<b>Docket Number:</b>	08-AFC-08A
<b>Project Title:</b>	Hydrogen Energy Center Application for Certification Amendment
<b>TN #:</b>	201256
<b>Document Title:</b>	Responses to September 2013 Workshop Requests: Biological Resources
<b>Description:</b>	N/A
<b>Filer:</b>	URS
<b>Organization:</b>	URS
<b>Submitter Role:</b>	Applicant Consultant
<b>Submission Date:</b>	11/18/2013 4:58:12 PM
<b>Docketed Date:</b>	11/18/2013

# Responses to September 2013 Workshop Requests: Biological Resources

Amended Application for Certification  
for  
**HYDROGEN ENERGY CALIFORNIA**  
(08-AFC-8A)  
Kern County, California

**FIGURE 4**

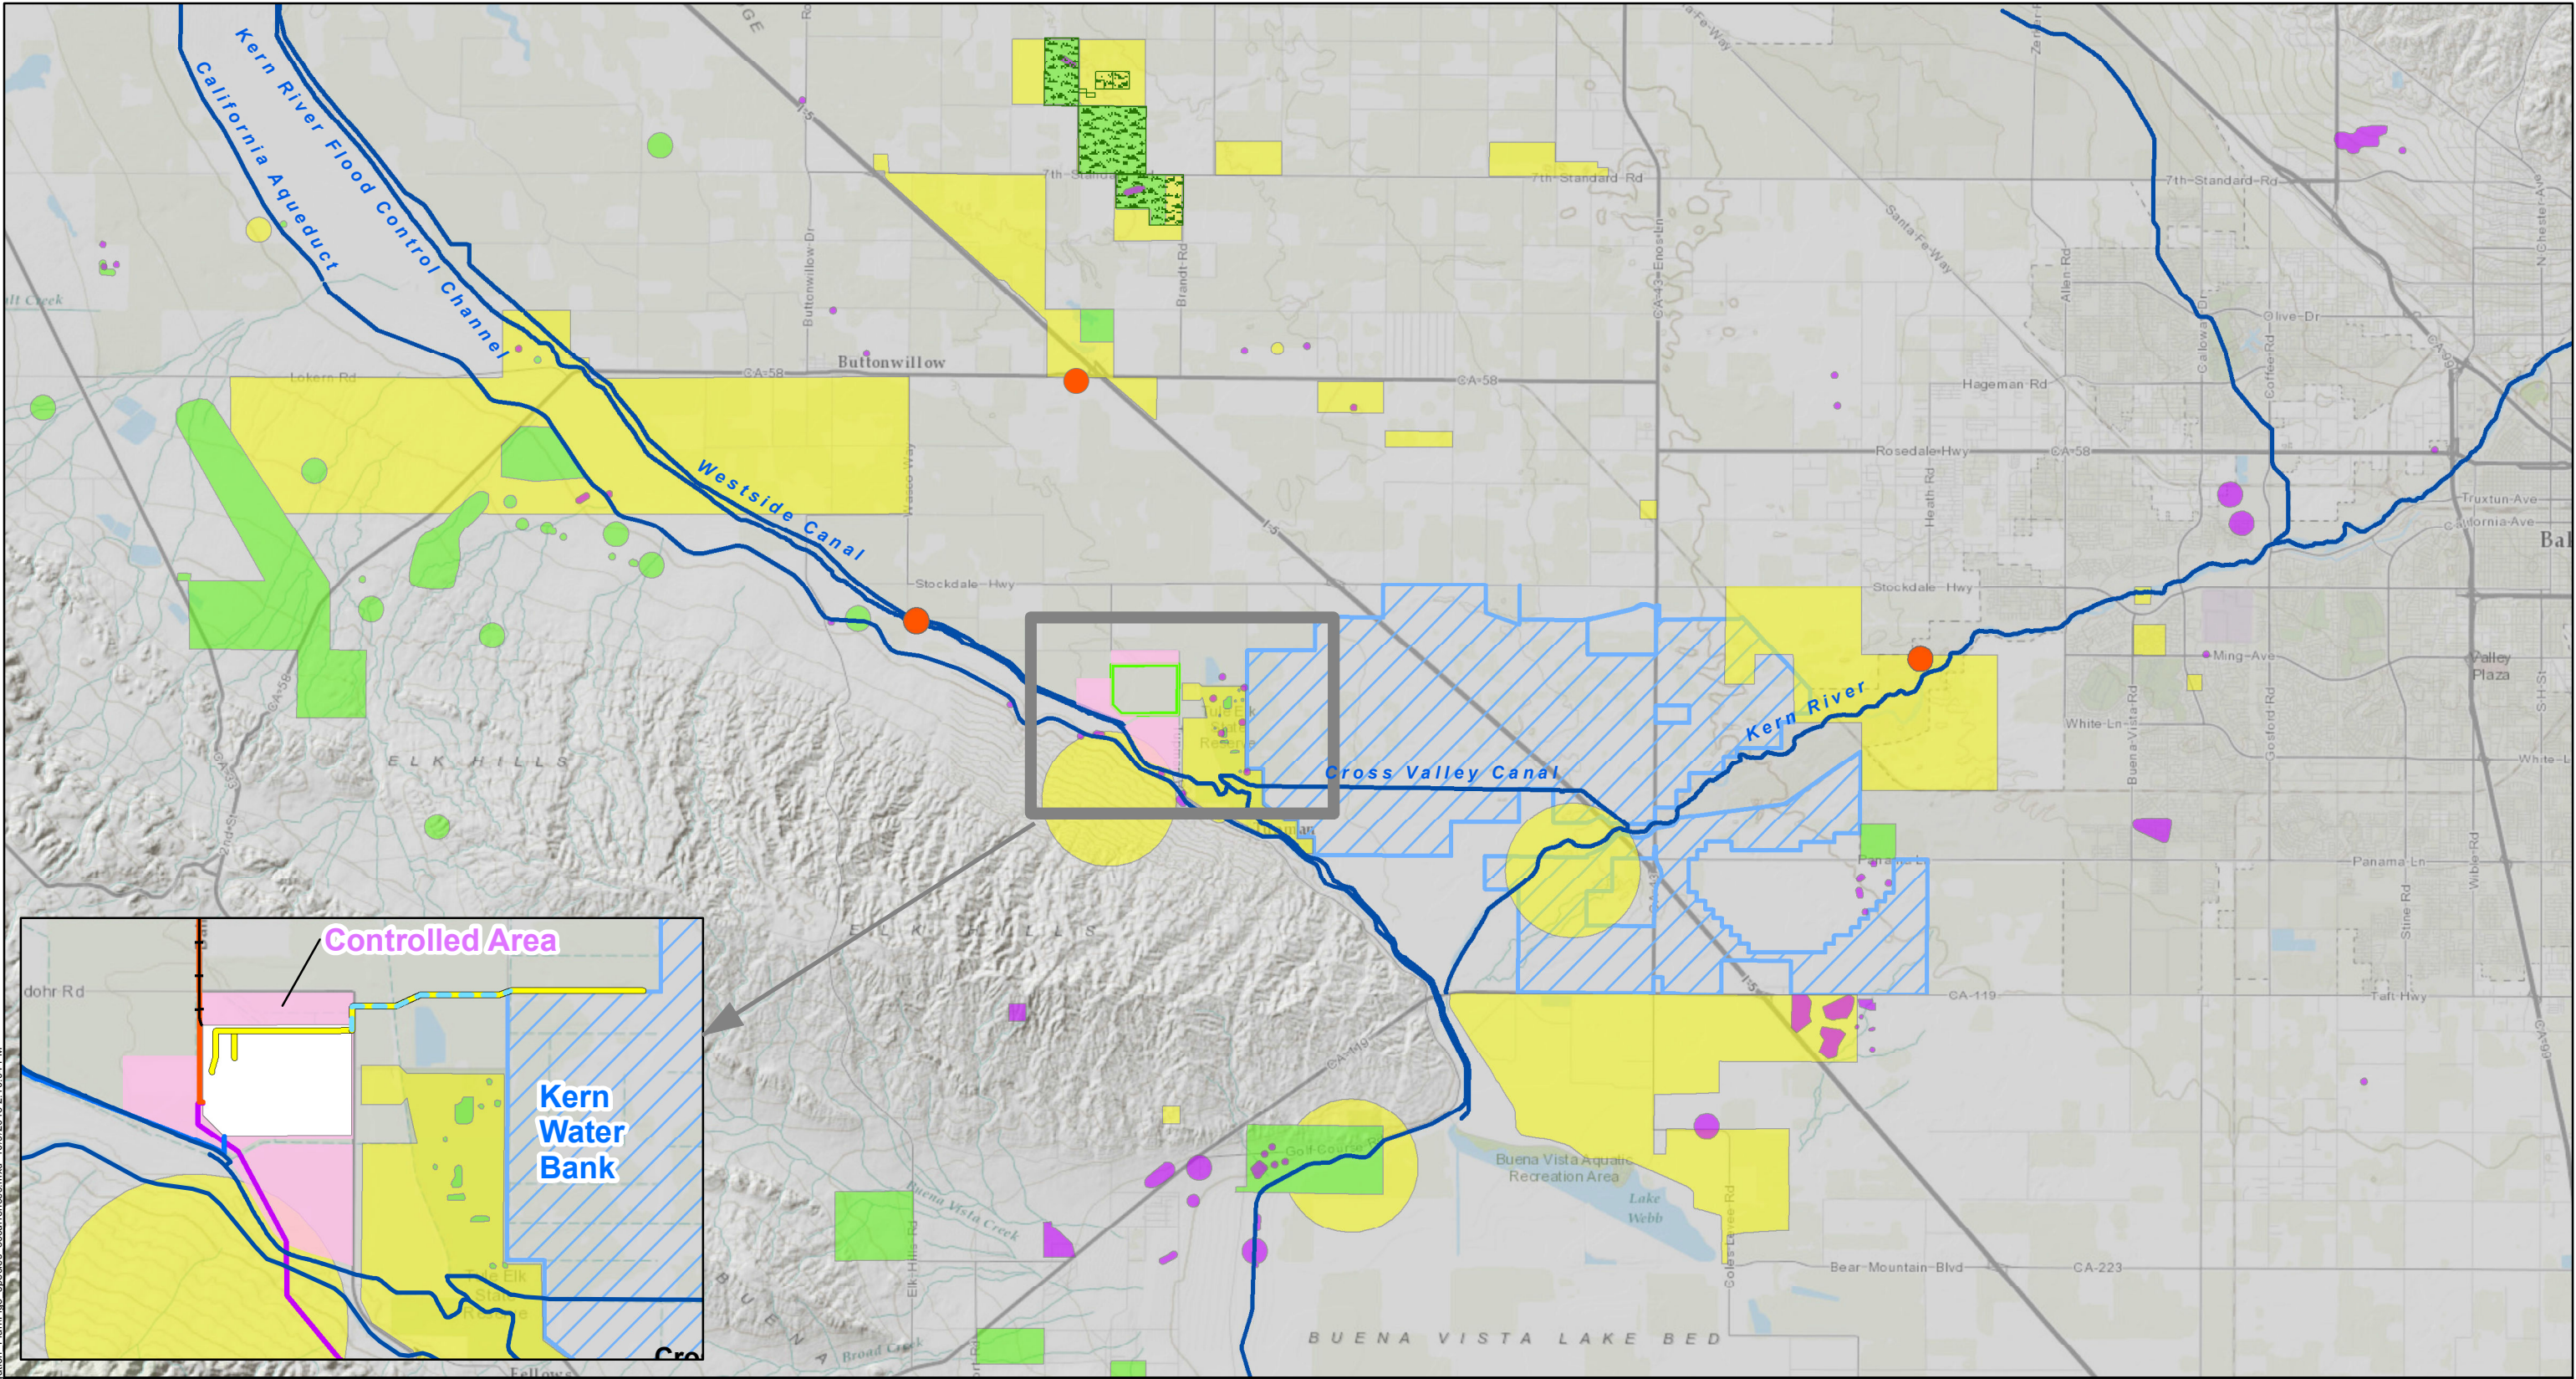
***BIO-10. Provide map of habitats in the project area***

Figure 4 in the HECA Mitigation Plan for Biological Resource Impacts (see Attachment BIO-6 in this submittal) identifies the habitats in the HECA Project Area. The classification of the habitat types is consistent with the previous submittals provided by HECA.
